Clonburris SDZ, Reg ref: SDZ22A0010
Dublin 22

Ronan Mac Diarmada & Associates
Landscape Architects & Consultants

**CLARIFICATION OF ADDITIONAL
INFORMATION RESPONSE**

March 2023

New Local Green Corridor & Green Link Plan

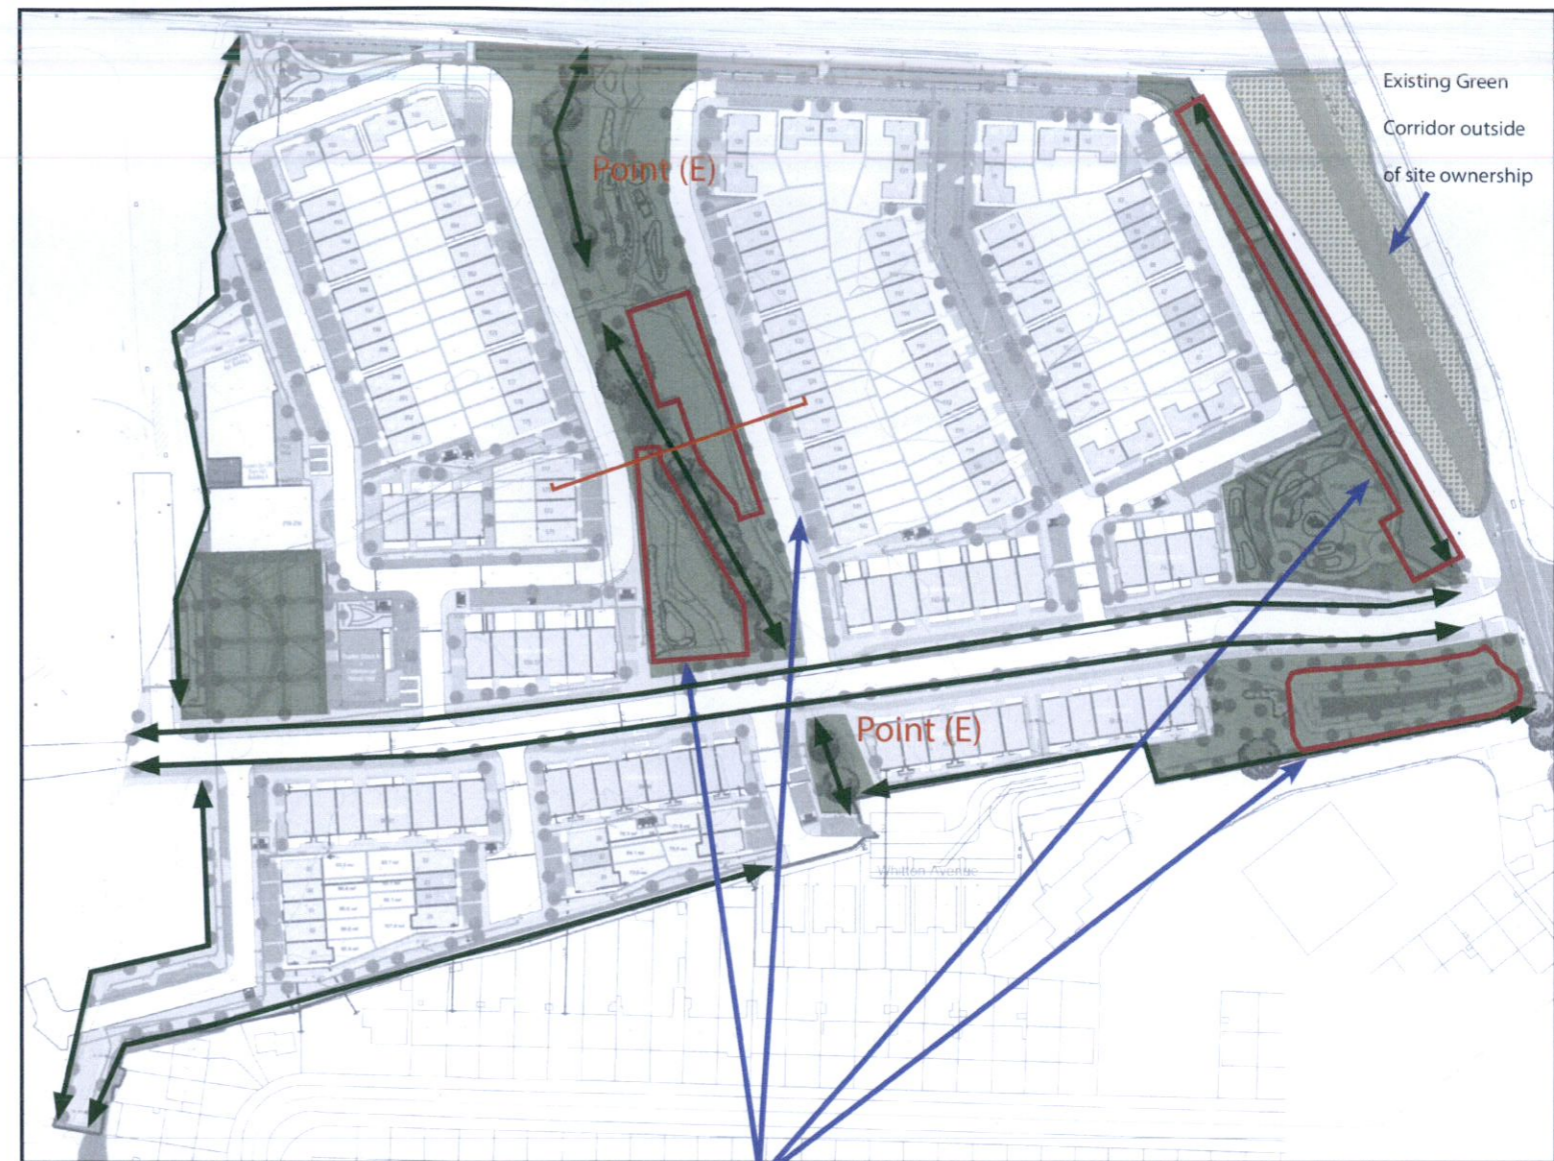
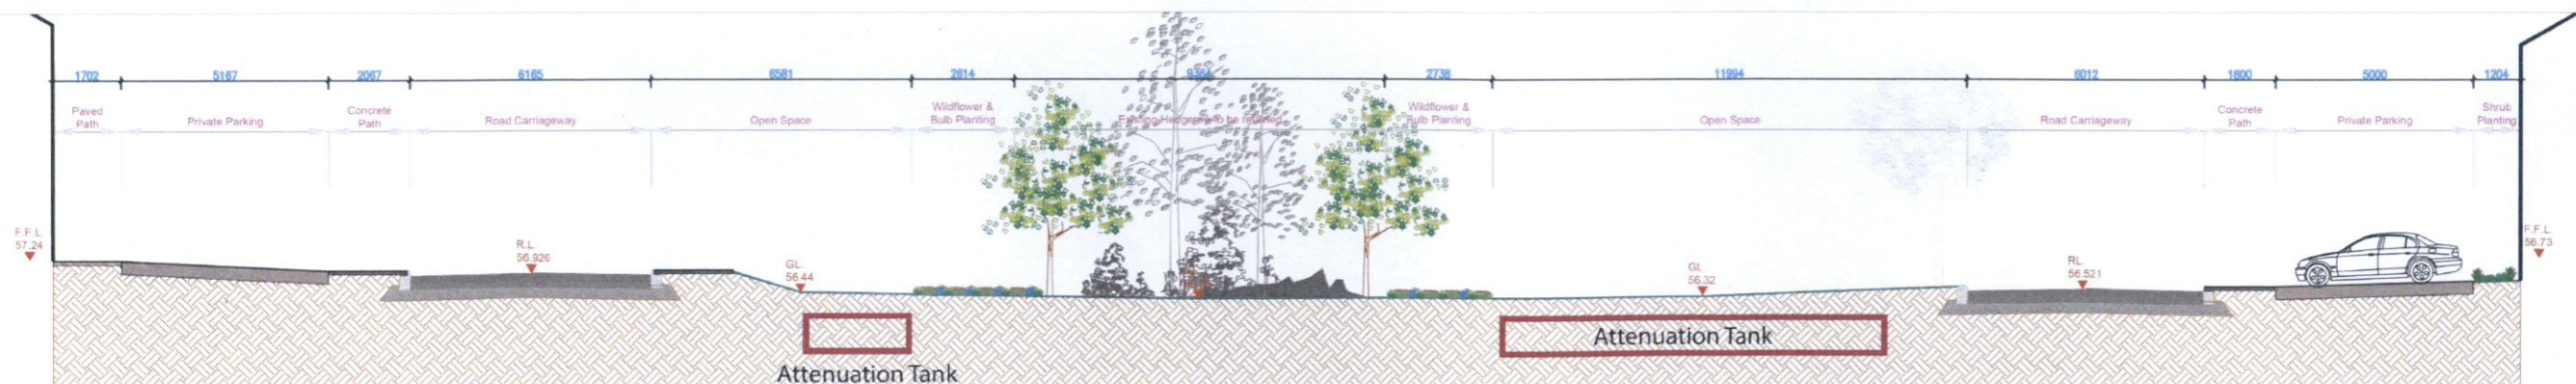
(e) A Local Green Corridor approximately N-S through the centre of the development increasing the retention of trees and hedgerows;

(e) The local green corridor running N-S through the centre of the development is relatively untouched, SDCC infrastructure walls, attenuation are located in this area. We wish to retain this hedgerow as much as possible, subject to SDCC Works. Part of the hedge has been removed due to the agreed link road running East - West (Distributor Road as prescribed by SDCC) through the site and some trees will be removed as per Arborist recommendation.

Street Tree Provision in Local Streets and Homezones

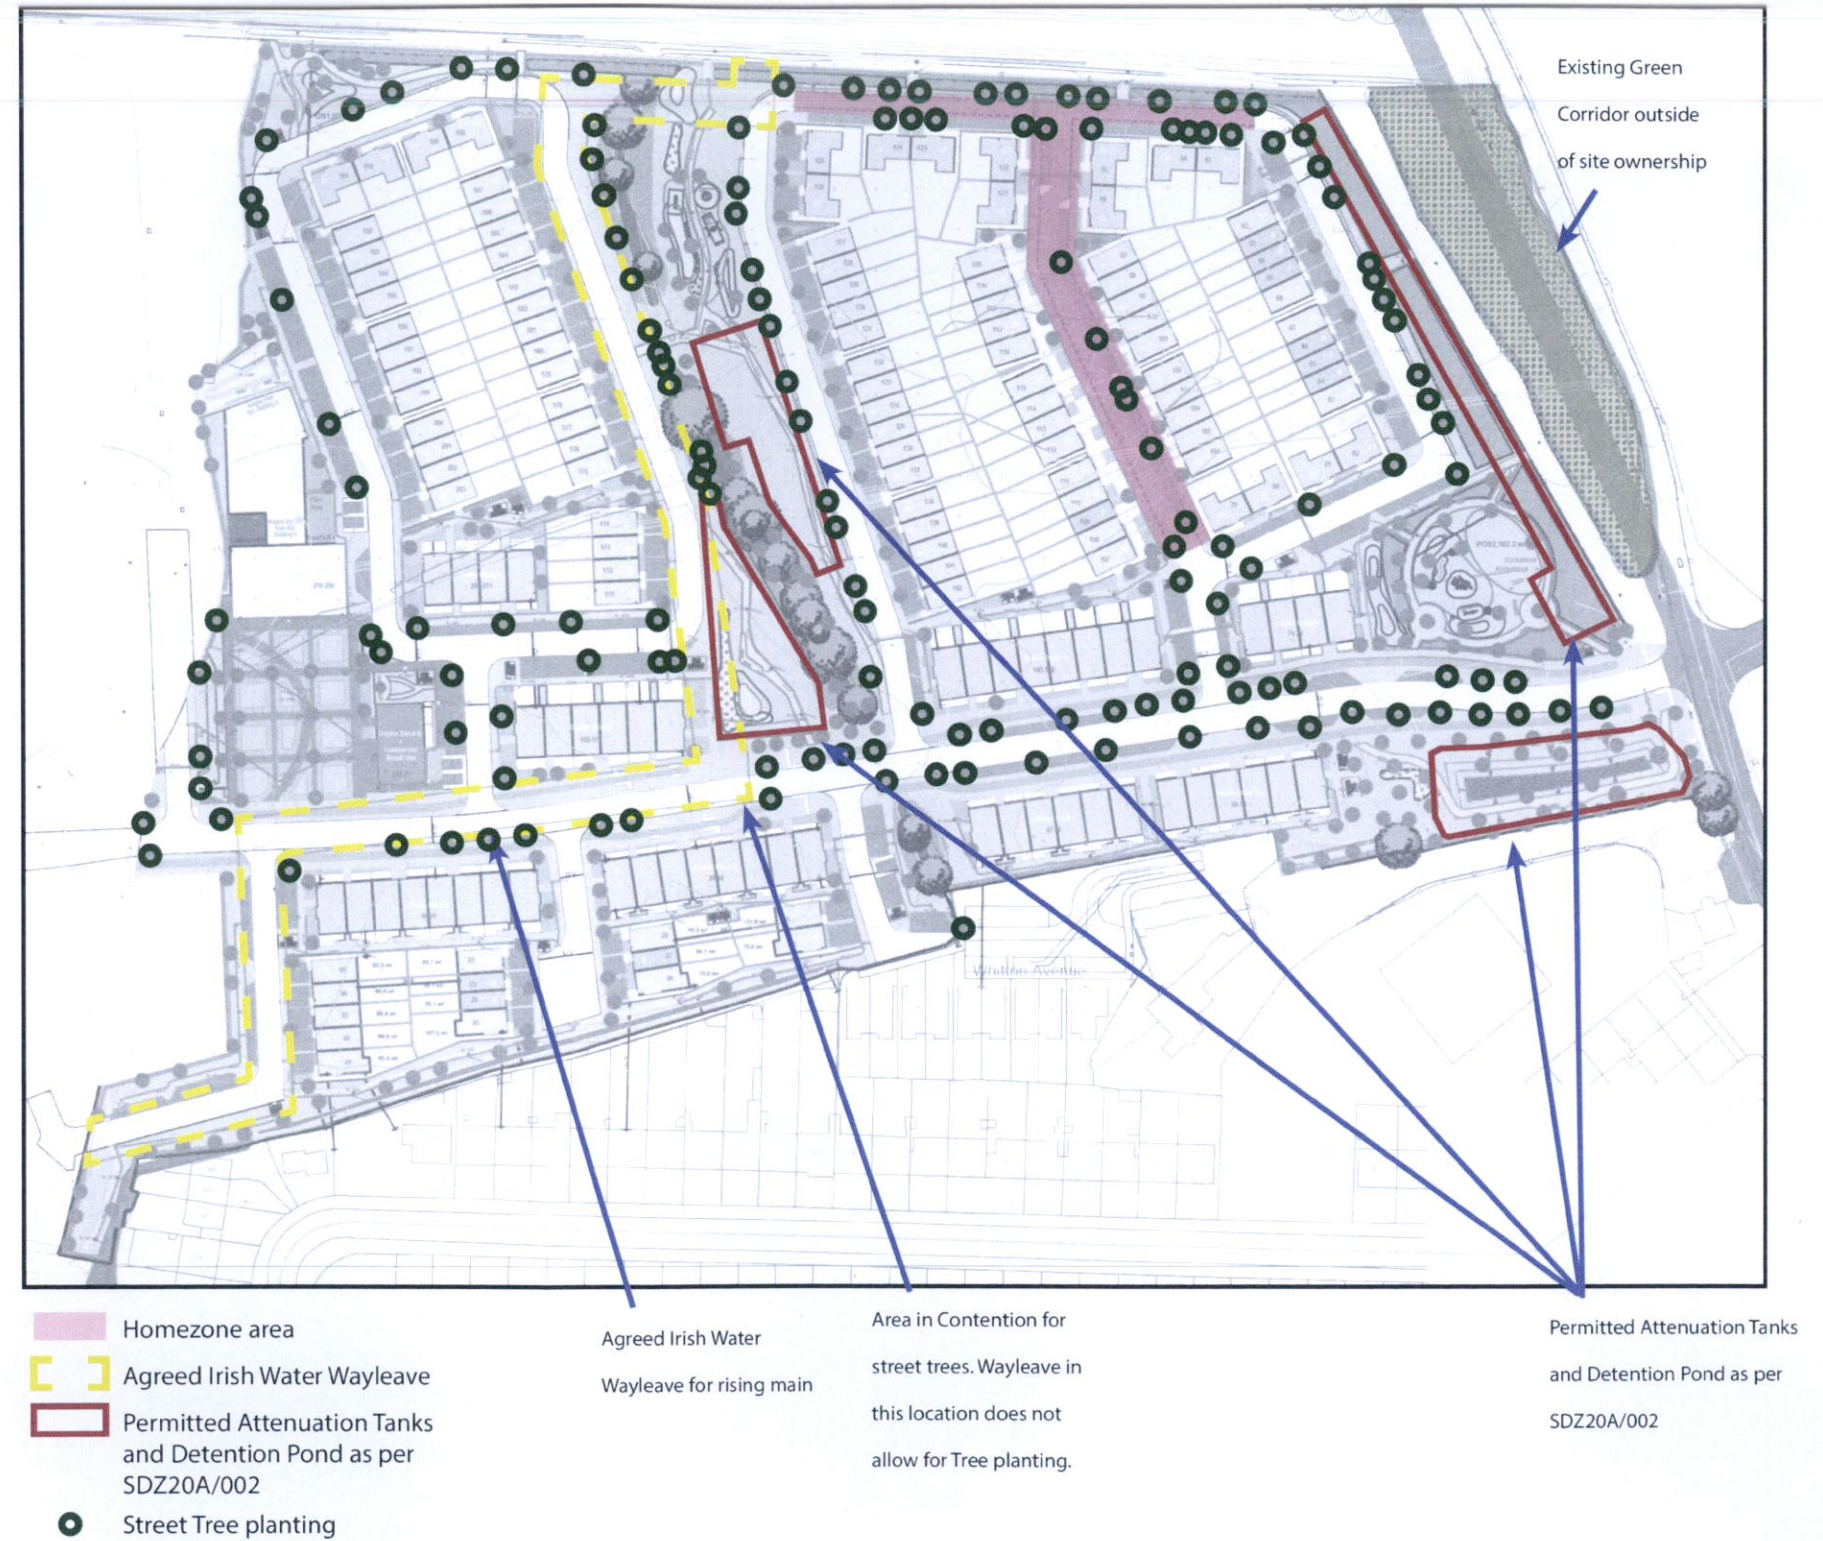
(f) Provision of street trees on both sides along local streets and homezones.

(f) Street trees have been provided on both sides along local streets and homezones where possible. There is a wayleave located on site and also lighting standards dictating the placement of trees so there may be areas of the streets where tree planting cannot occur.

Permitted Detention Basin Location

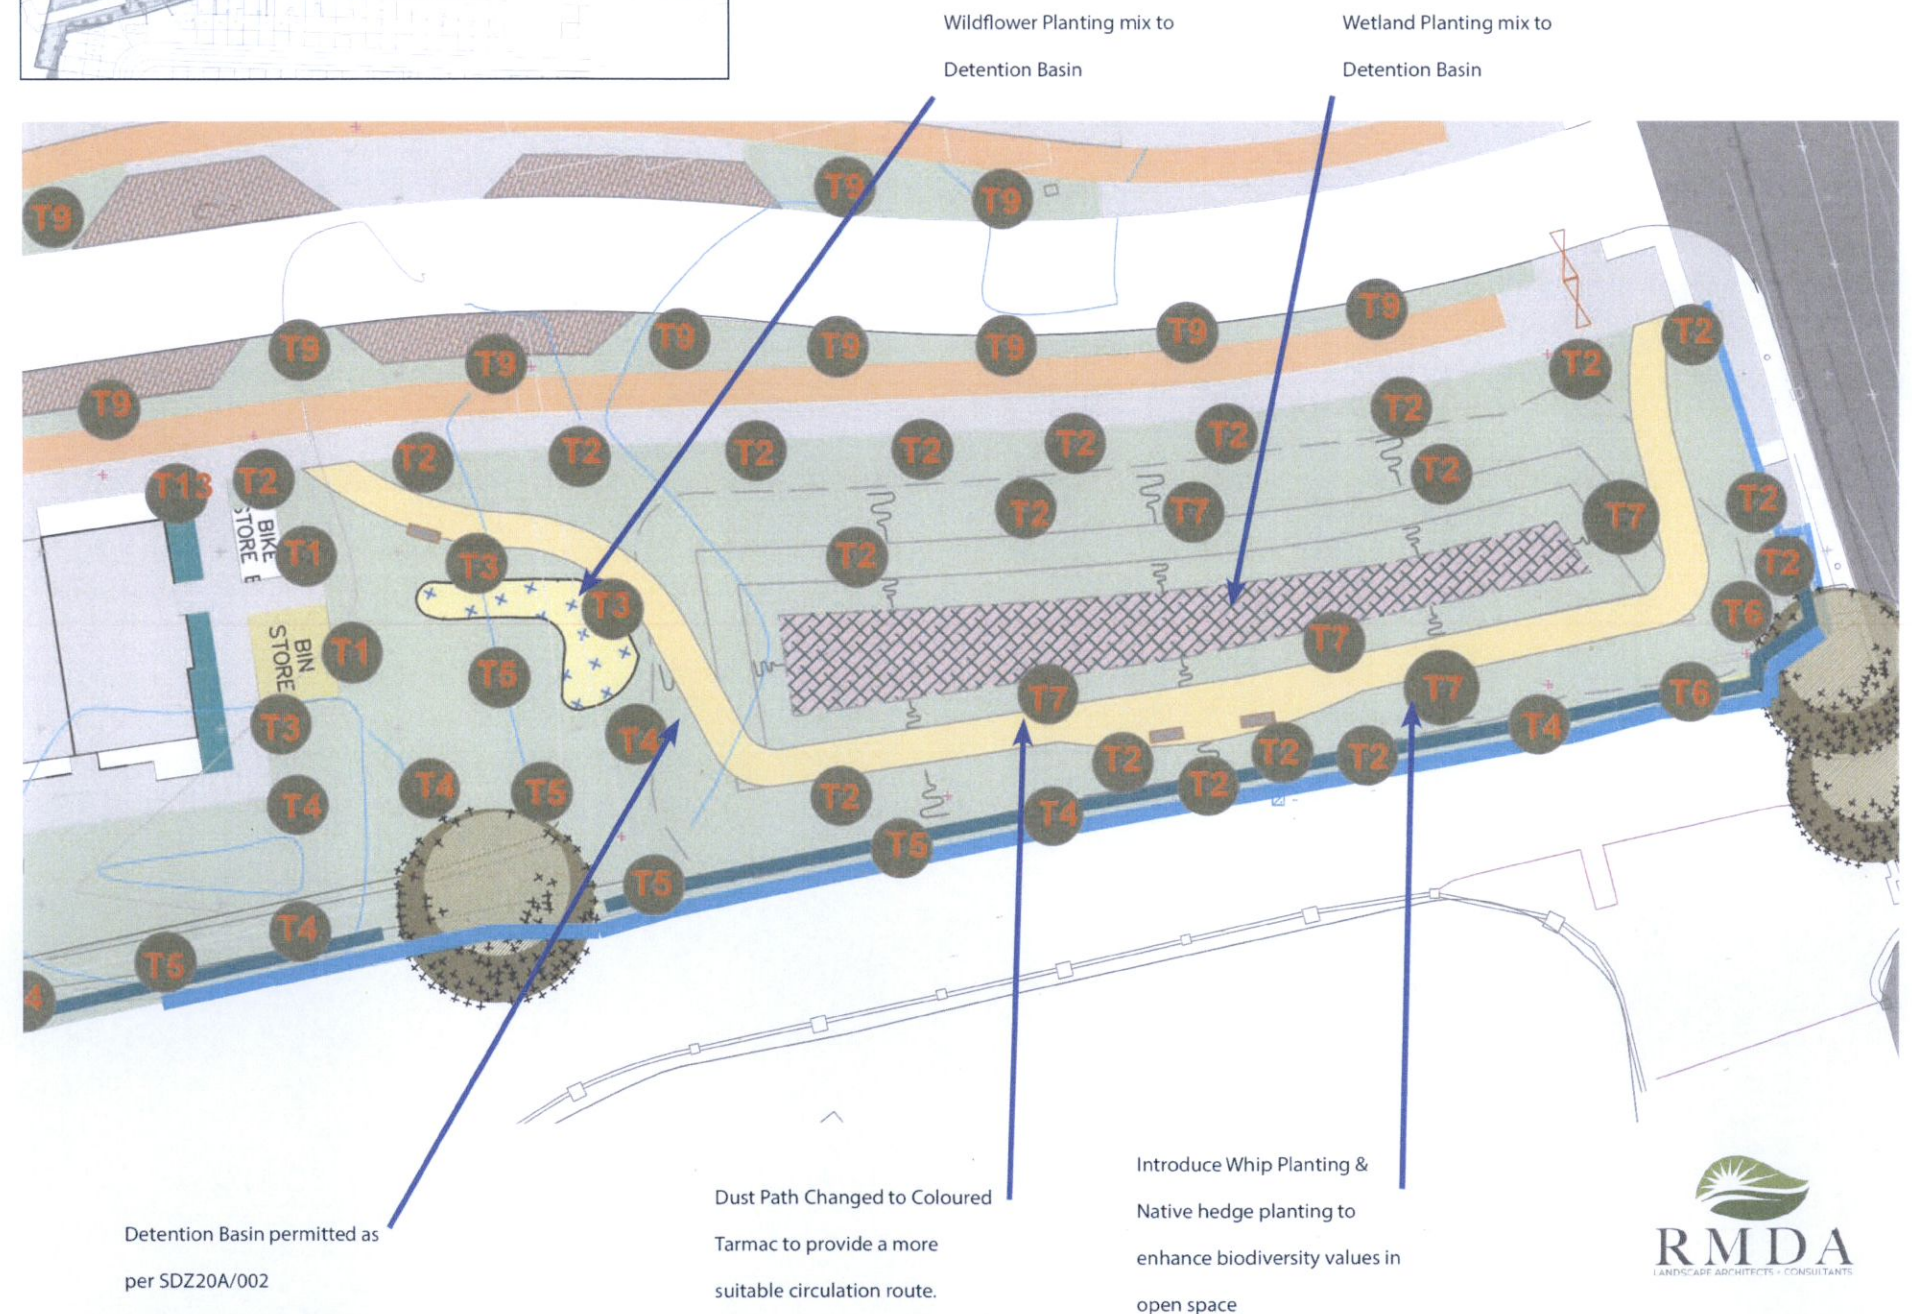
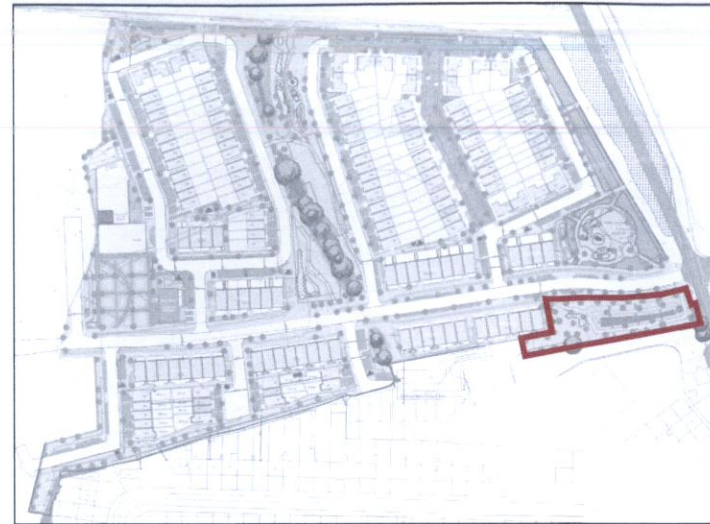
The Public Realm Section have raised concerns in relation to the landscaping design around the permitted pond. 'The proposed engineered detention basin is unacceptable in a Public Open Space area. It has not been designed in accordance with the Councils SUDS Guidance and is lacking in amenity and biodiversity value. Further natural SuDS should be used to create/enhance the Local Green and Strategic Green Infrastructure Links required by the Planning Scheme. The proposal for a gravel path in an area that is designed to flood is also not acceptable.' Further above ground SUDS measures should be considered where appropriate and incorporated into the landscape design.

The design for the detention basin has been previously agreed for this area. This forms part of a granted scheme. We propose the use of wetland planting and tree species suitable to wet areas to provide biodiversity and amenity value to the open space.

The gravel path has been changed to coloured tarmac path to provide a more suitable surface.

A path for amenity has been included to work with the slopes as per the granted scheme. The path provides a circulation route around the detention basin for amenity purposes.

The path, seating and planting shall provide amenity for the residents and the other users.

Tree Pit & Urban Soil Detail

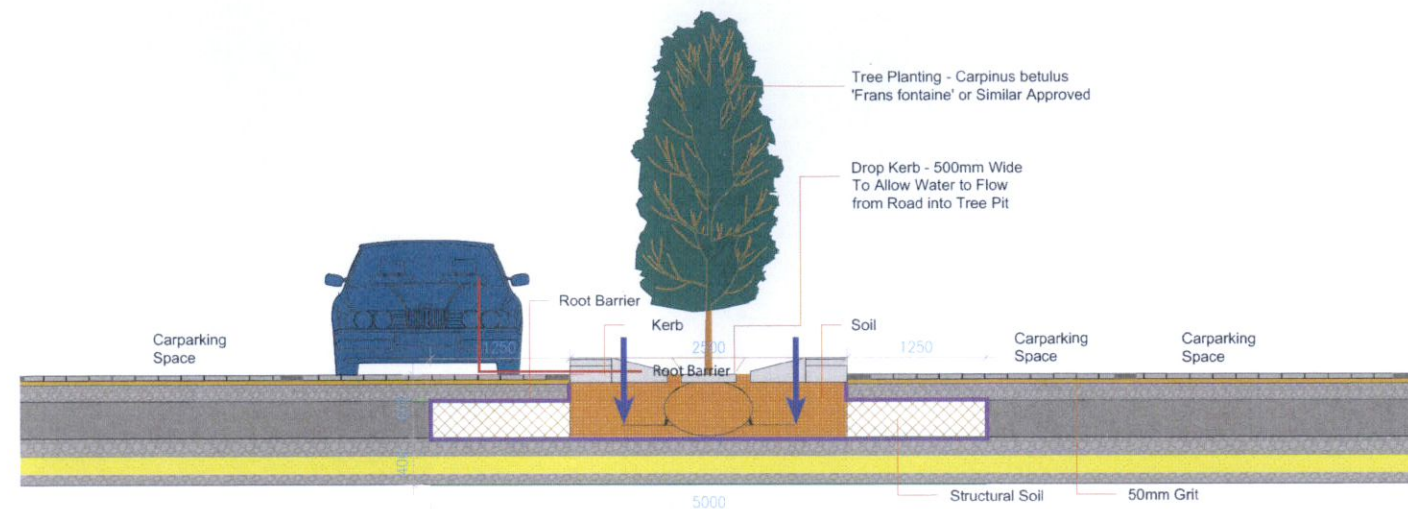
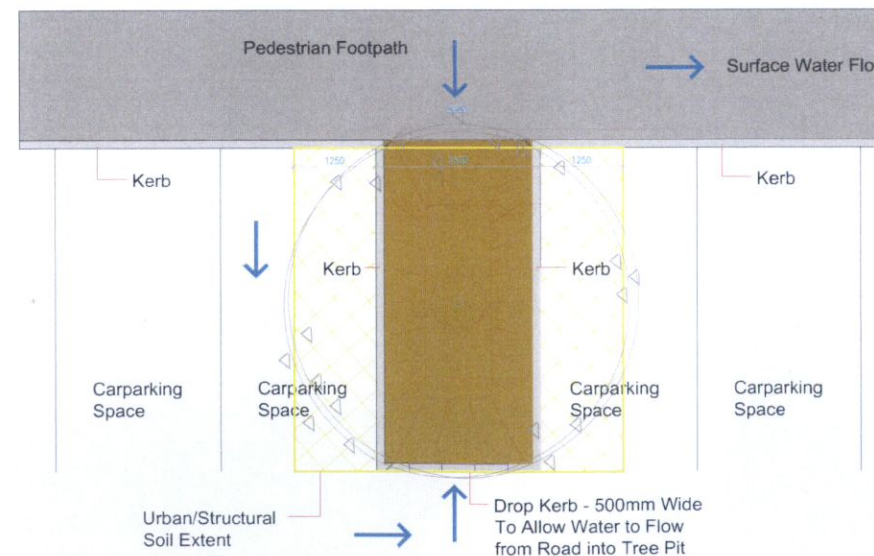
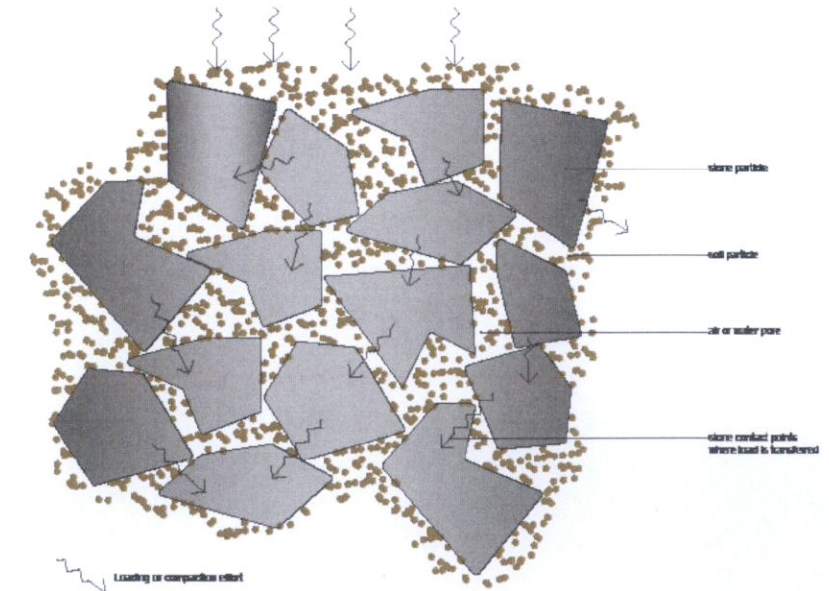
iii. All Street Trees planted within the Public Realm shall have suitable tree pits that incorporates SuDS features including sufficient growing medium.

iv. Street Trees to be planted at:

- (i) All streets have been provided with street trees where possible as per the Clonburris Planning Scheme
- (ii) Street trees have been provided in local streets and homezone areas.
- (iii) All street trees planted within the public realm have been provided with suitable tree pits, incorporating SuDS features. Please refer to tree pit detail.

- Minimum 18-20m girth along local streets
- Minimum 16-18cm girth on intimate local roads, i.e. homezones

However, we must note that these have a higher note of failur due to size. We have provided an alternative list with smaller sizes to due to availability of trees and to prevent larger trees from not adapting to ground conditions when planted.

It is our view that a size smaller would be more beneficial & sustainable 14-16cm. - 16-18cm.
